Meeting 3&4

Comment Discussion

P802.3ck Chief Editor

Cross-Clause Topics

Figure 120G-10—Recommended channel insertion loss
 ~44 dB @ 53.125 GHz

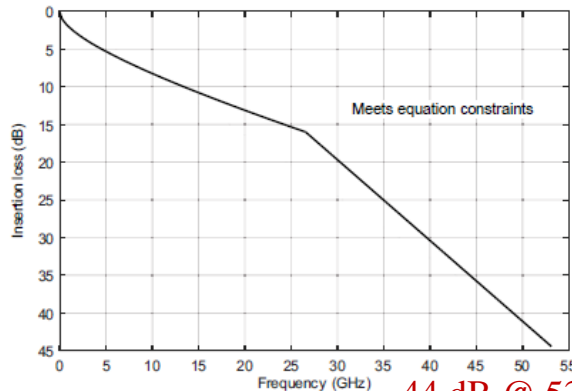
CI 120G SC 120G.4.1 P 238 L 34 # 255

I'm sure there could be an acceptable channel that failed this mask at 45 GHz

SuggestedRemedy
Make the straight section curve down and/or truncate it at 50 GHz

It makes sense to align the high-frequency limit with channel IL specifications in 162, 163, and/or 120F. However, even those are inconsistent.
162 specifies 40 GHz.
163 specifies 45 GHz.
120F specifies 53.125 GHz.
For task force discussion.

Figure 163-6—Channel insertion loss limit
 ~60 dB @ 45 GHz

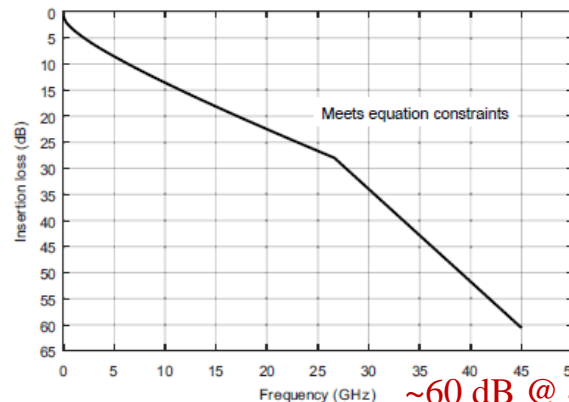
CI 163 SC 163.10.2 P 186 L 28 # 232

A -80 dB response at 45 GHz, 32 dB below the response at Nyquist, can't matter, but a respectable channel could fail this limit.

SuggestedRemedy
Replace the straight part of the limit with one that curves down.

Equation for IL mask is not provided.
The suggested remedy does not provide sufficient details to implement.
For task force discussion.
